AI#2 Appendix C

Peat Technical Note

Response to the SEPA Objection (17 April 2020)

3.2 Turbine 4

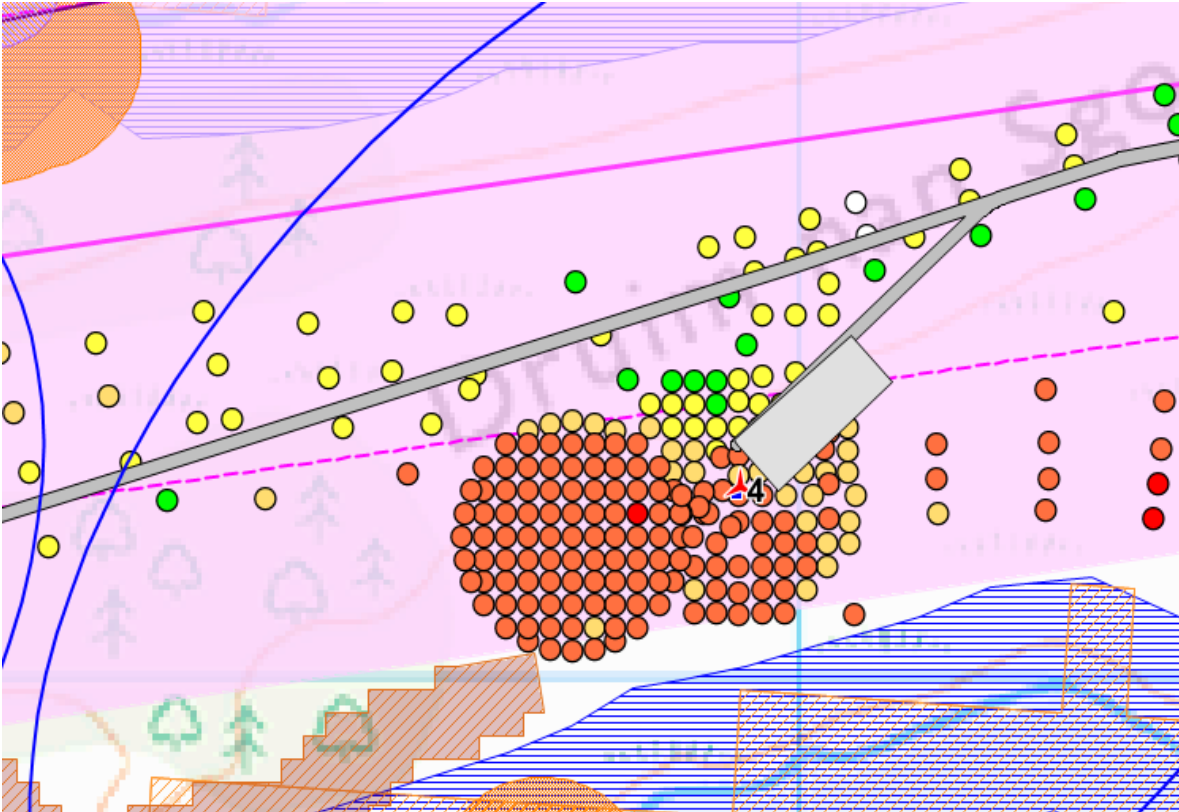
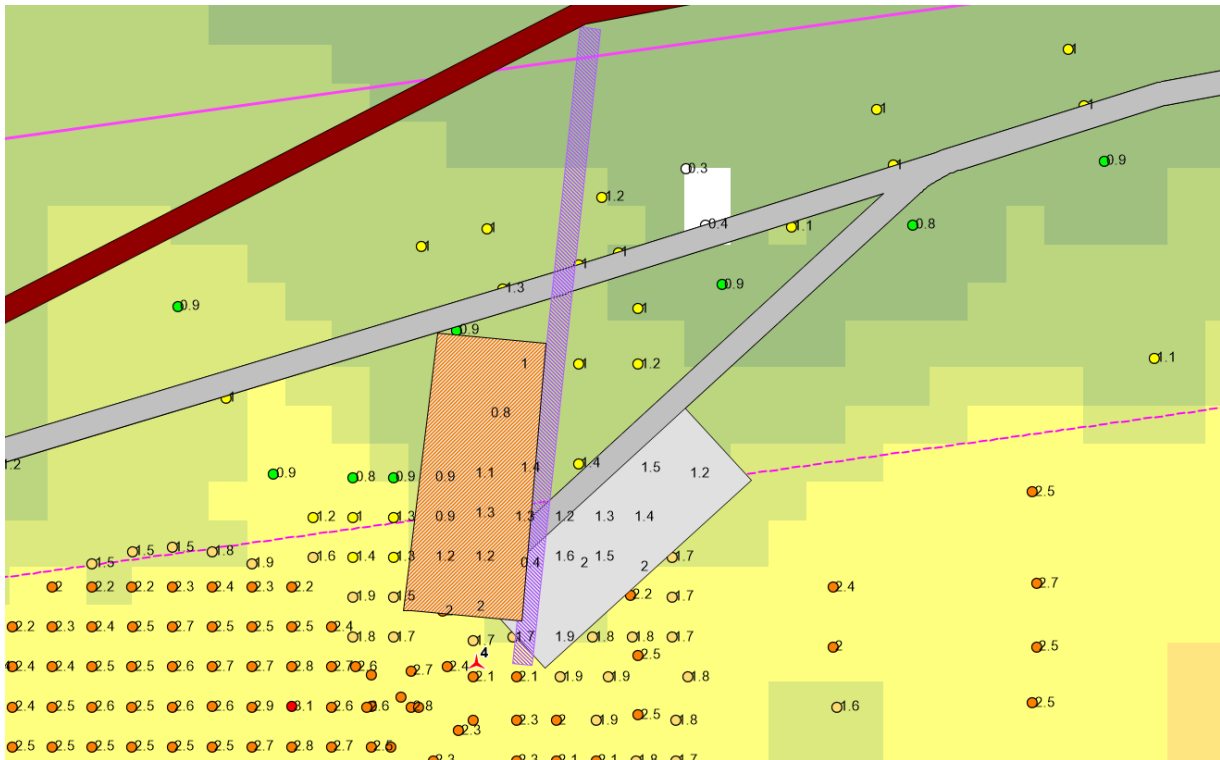
- 3.2.1 SEPA identified that Turbine 4 (T4) is located within peat that is 2-3m deep and should be moved into shallower peat to the north where peat depths are 0.5-2m (green area).

- 3.2.4 The move requested by SEPA was reviewed and due to a JRC scanning telemetry link, EITSEAL WIG, there would be issues with the turbine blade moving north and therefore closer to the link. Should this move take place, it would result in an objection from JRC. However, a small move to the north east parallel to the link would be potentially feasible reducing impact on peat whilst maintaining the required distance from the telemetry link.

- 3.2.5 **Figure 3.1b** shows the proposed slightly amended location and orientation of the crane pad out of deeper peat.
- 3.2.6 Relocating the crane pad will also result in a small change to the layout of the access track to the north. This is because a straight section of road approximately 160m is required from crane assembly. This amendments to the road layout are identified as the maroon line. The interpolation of peat probing data suggests that peat depths in this area are lower than those to the south.

- 3.2.8 In relocating the crane pad and road section here, a saving of 726.8 m³ of peat (approximately 7.5%) could be achieved when compared to the as submitted scheme.

3.3 Turbine 5

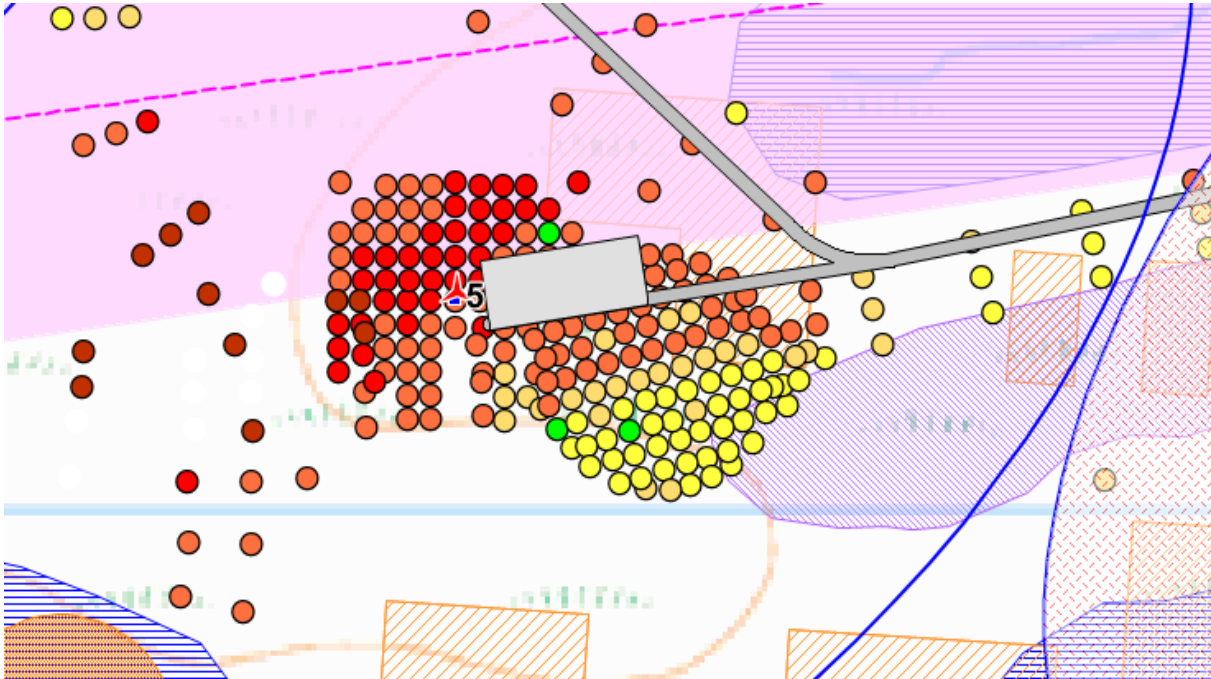
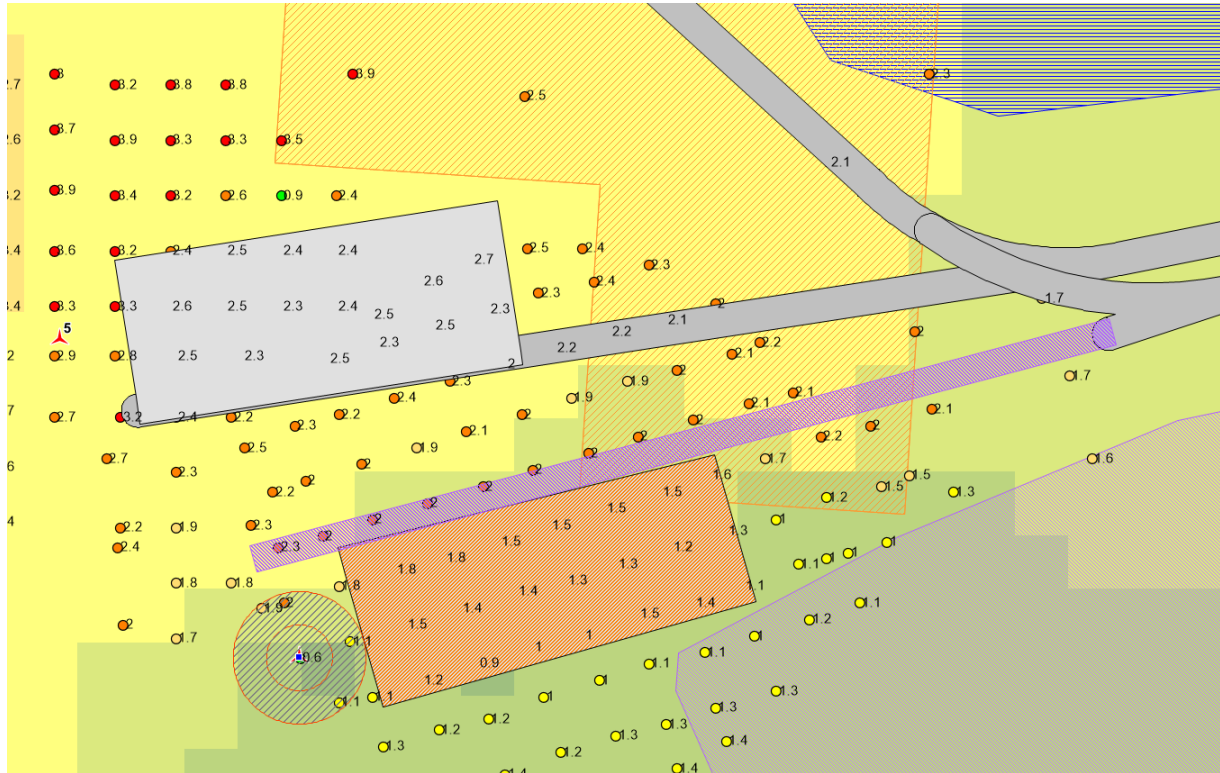
- 3.3.1 SEPA identified that Turbine 5 (T5) is located within peat that is 3-4m deep and should be moved into shallower peat to the south-east where peat depths are 0.5-2 m (green area).

- 3.3.4 The move requested by SEPA was reviewed and although the peat to the south east is shallower, there are however, areas of pluvial flood hazard (orange hashed areas), and sensitive vegetation (purple hashed areas) close to the infrastructure. A move into these areas would result in a loss of the sensitive peat vegetation and may result in issues being raised by SNH.

- 3.3.5 **Figure 3.2b** shows the proposed slightly amended location of T5 and re-orientation of the crane pad.
- 3.3.6 There is potential to move the turbine slightly to the south and flip the crane pad to reduce effects on peat. This would reduce the maximum peat depths to 2.5m.
- 3.3.7 Relocating T5 would result in a small change to the layout of the access track to blend into the new location.
- 3.3.8 Before reaching this conclusion, a number of other locations were identified, and dismissed as they would not result in a saving of peat, or an increase in peat loss.
- 3.3.9 In relocating the turbine, crane pad and road section here a saving of -1,711.9m³ of peat, (approximately 42%) could be achieved when compared to the as submitted scheme.

3.4 Turbine 11

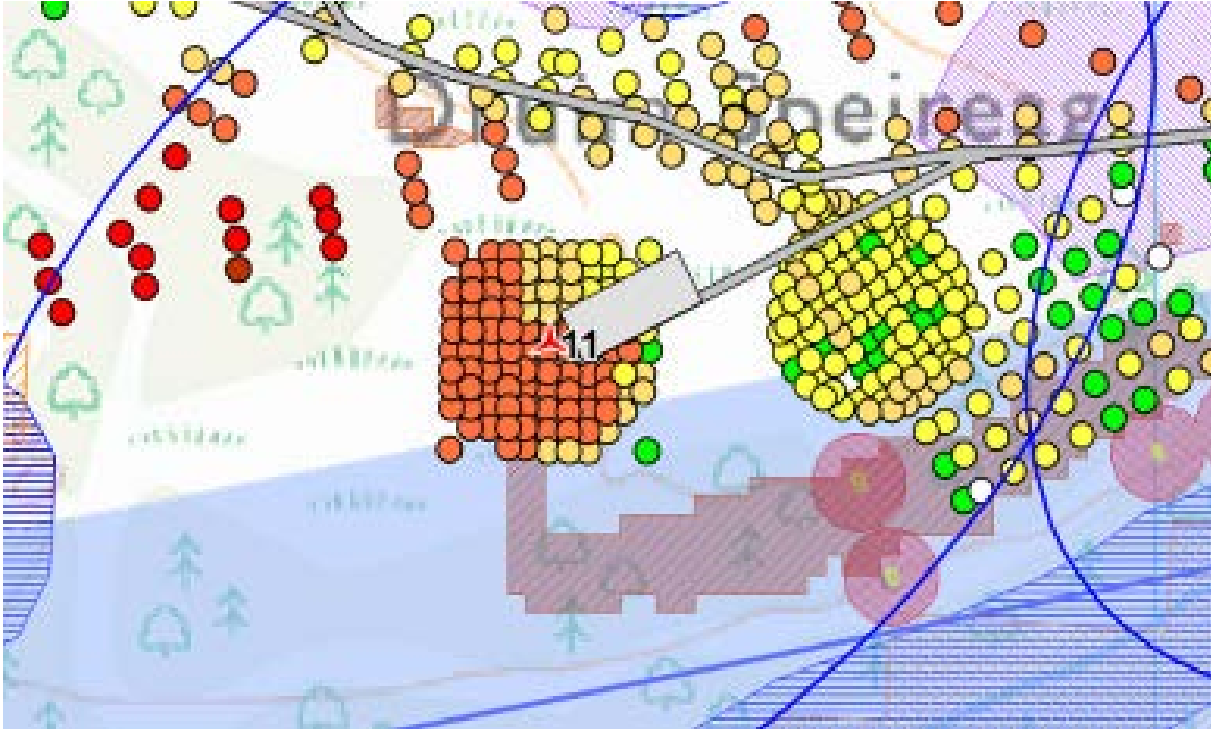
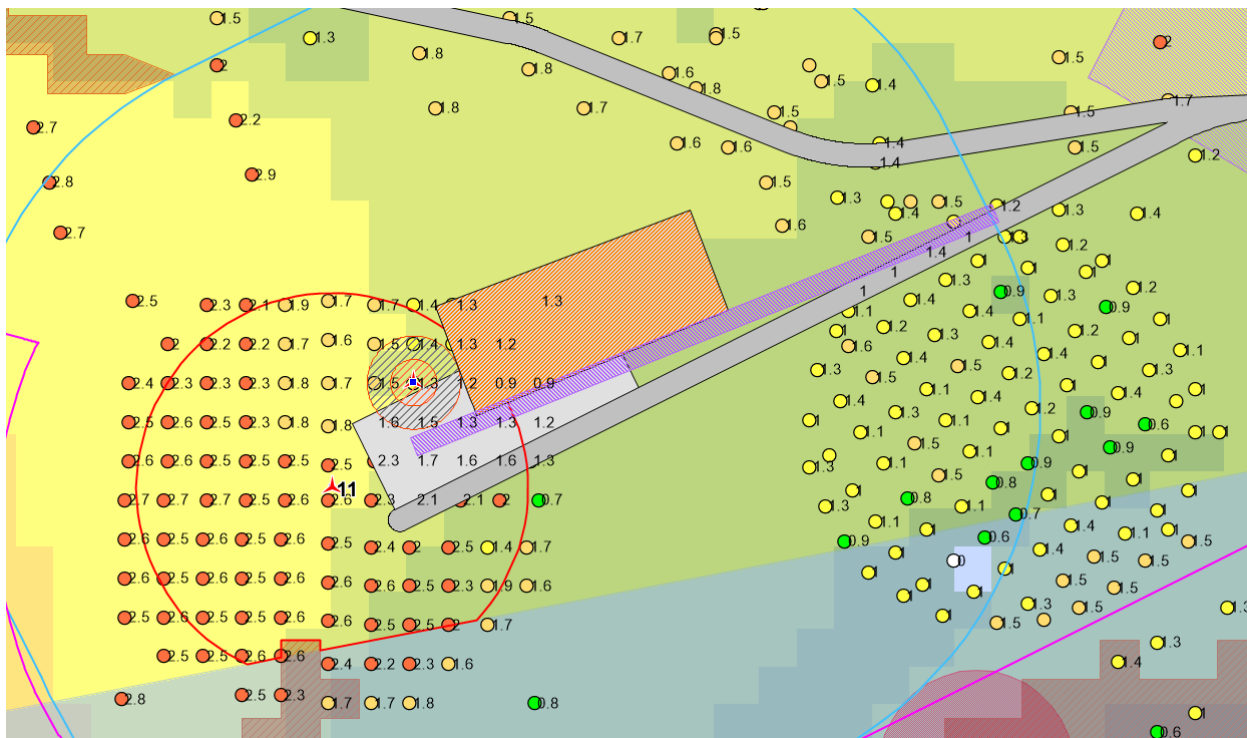
- 3.4.1 SEPA identified that Turbine 11 (T11) is located within peat that is 2-3m deep and should be moved into shallower peat to the north-east where peat depths are 0-2m (green area).
- 3.4.2 **Figure 3.3a** shows the as submitted turbine location for T11, including all the relevant infrastructure constraints as well as the peat depths.
- 3.4.3 The move requested by SEPA was reviewed, and currently T11 is 590m from T10 and 660m from T13. Based on a wake separation of 5x3 rotor diameters (750m x 450m at 220 degrees), there may be scope to move a little north east. However as shown in the **Figure 3.3a** for Turbine 11, there is limited scope to move north east without causing significant issues in terms of wake effect, and therefore turbine efficiency, especially if T13 (see **Section 3.5**) is moved south through micrositing.

- 3.4.4 **Figure 3.3b** shows the proposed amended location of T11. This moves the turbine slightly north east, and out of peat depths of 2.6m, into a peat depth of 1.3m and moves the crane pad into shallower peat. The relocation of T11 would result in a slight change to the road infrastructure.
- 3.4.5 Before reaching this conclusion, a number of other locations were reviewed including positions further north, and dismissed as they would result in significant wake separation issues, in particular T13 as its alternative position would be south of its current position and toward T11. Moving to the south would have significant additional peat excavation issues and would not result in any peat savings.
- 3.4.6 In relocating the turbine, crane pad and road section here a saving of 412m³ of peat (approximately 21%) could be achieved when compared to the as submitted scheme.

Figure 3.4a As Submitted Turbine Location and infrastructure

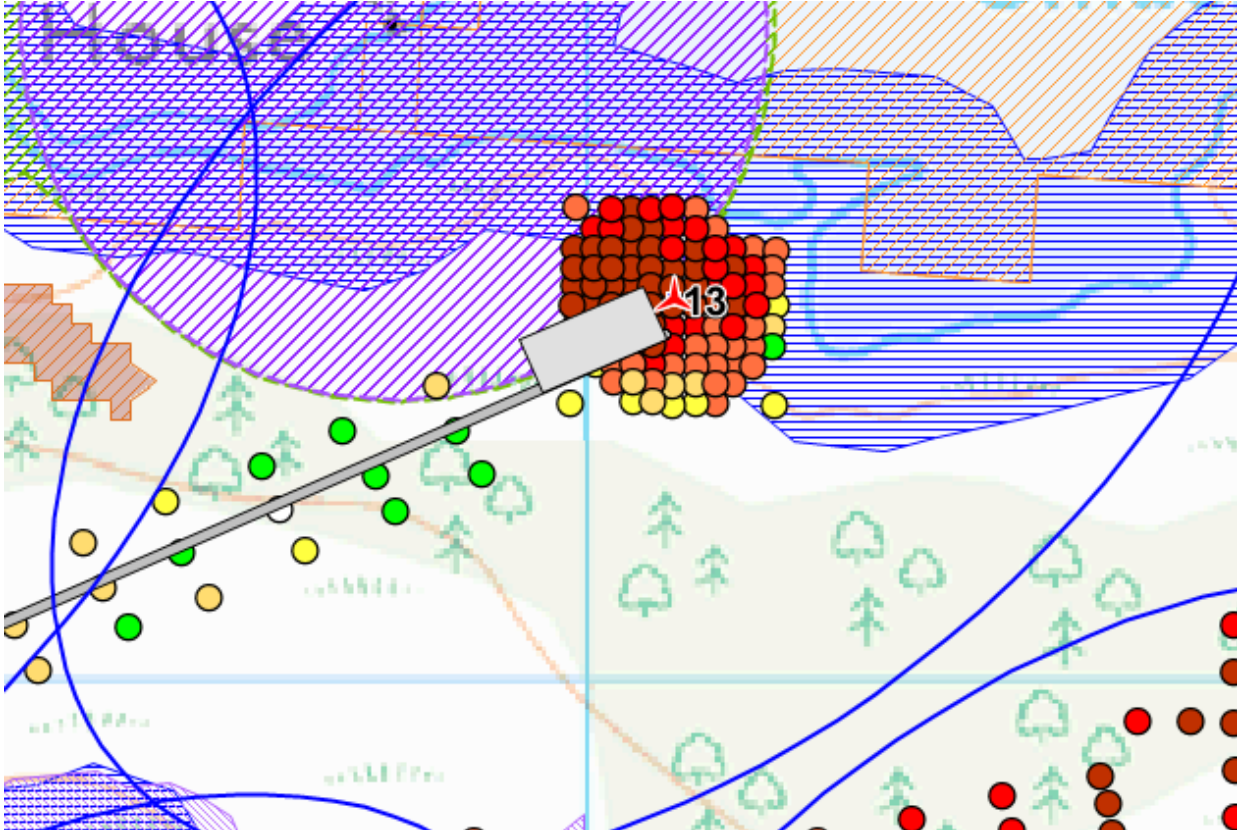
- 3.5.2 SEPA identified that T13 is located within peat that is greater than 4m deep and should be moved into shallower peat to the south or south-west where peat depths are 0-2 m (green area). SEPA's preference would be to see T13 re-located into the dark green probing depths (0.5-1 m) which also correlate with the area of forestry

- 3.5.3 The move requested by SEPA was reviewed, and currently T13 is 490m from T10 and 660m from T11. Based on a wake separation of 5x3 rotor diameters (750m x 450m at 220 degrees), there may be some scope to move a little south and bring the separation buffers closer together. It may be possible to move the turbines slightly to the south and flip the hard standing to reduce effects on peat. Although this moves the infrastructure closer to the wooded area.

3.6 Turbine 14

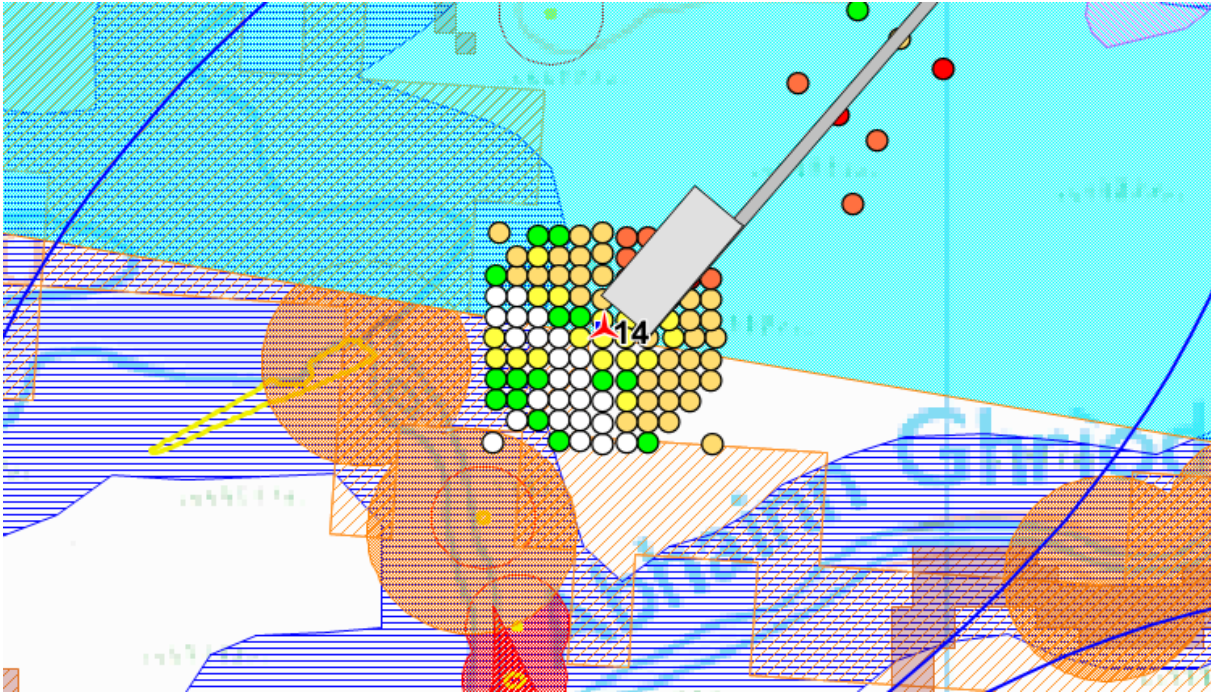
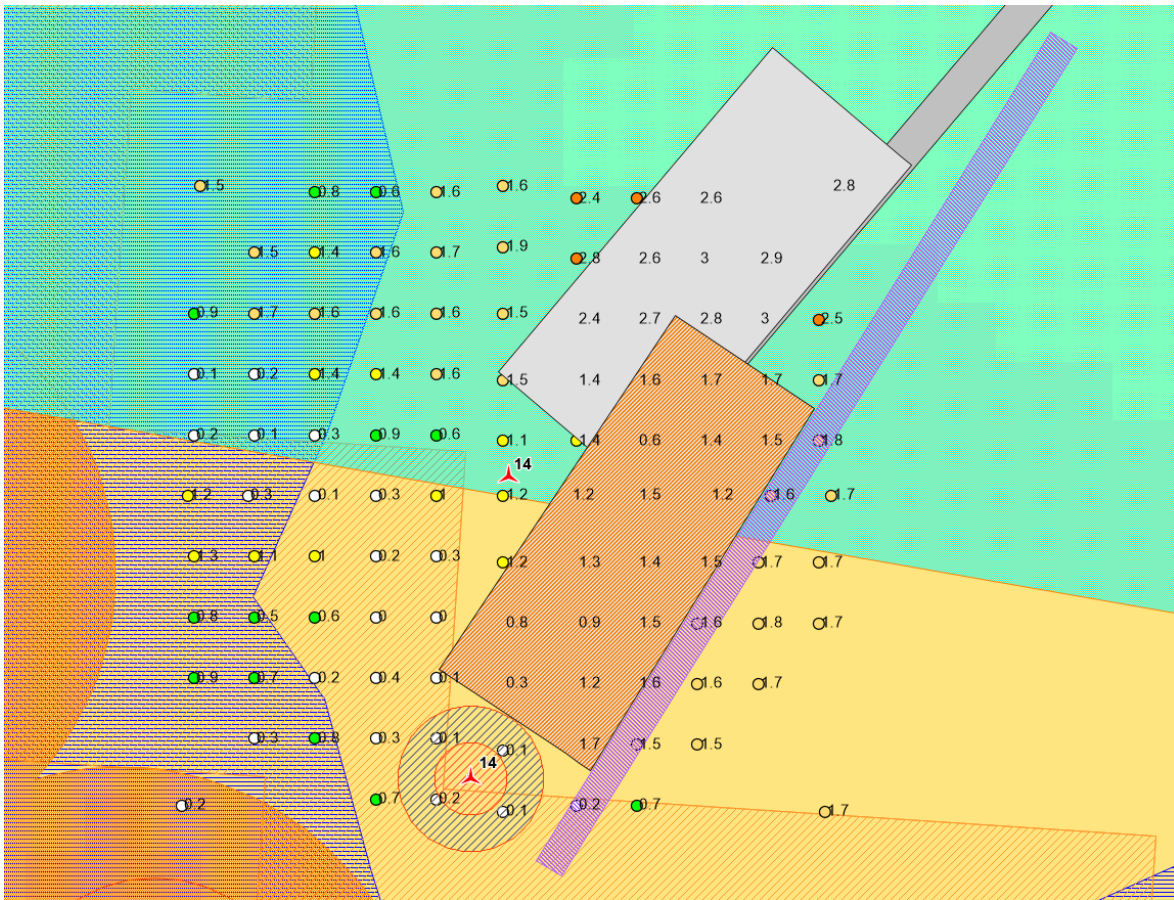
- 3.6.1 **Figure 3.5a** shows the as submitted turbine location, including all the relevant infrastructure constraints as well as the peat depths.
- 3.6.2 SEPA identified that the Turbine 14 (T14) crane pad is located within peat 2-3m deep and should be moved into shallow peat to the south, east or west where peat depths are 0-2m (green area).
- 3.6.3 This move was reviewed and this is a highly constrained area with an area of GWDTE directly to the south-west and the diver corridor to the north-east. There are also watercourse buffers, otter holts & flood risk to the south-west.
- 3.6.4 Notwithstanding these constraints, it may be possible to move the turbine and pad slightly to the south to further minimise effects on peat.

- 3.6.5 **Figure 3.5b** shows the proposed slightly amended location of T14 and its crane pad. This moves T14 out of 1.2m deep peat and into 0.1m deep peat, and moves the crane pad south into shallower peat.
- 3.6.6 Before reaching this conclusion, a number of other locations were identified but they would encroach into constraints such as sensitive otter habitat, and would not result in additional saving in terms of peat extraction. Other constraints were also identified (moderate classification GWDTEs), however this was not a determining factor on the proposed turbine and hard standing location as illustrated in **Figure 3.5b**.
- 3.6.7 In relocating the turbine, crane pad and road section here, a saving of 1,714m³ of peat (approximately 50%) could be achieved when compared to the as submitted scheme.
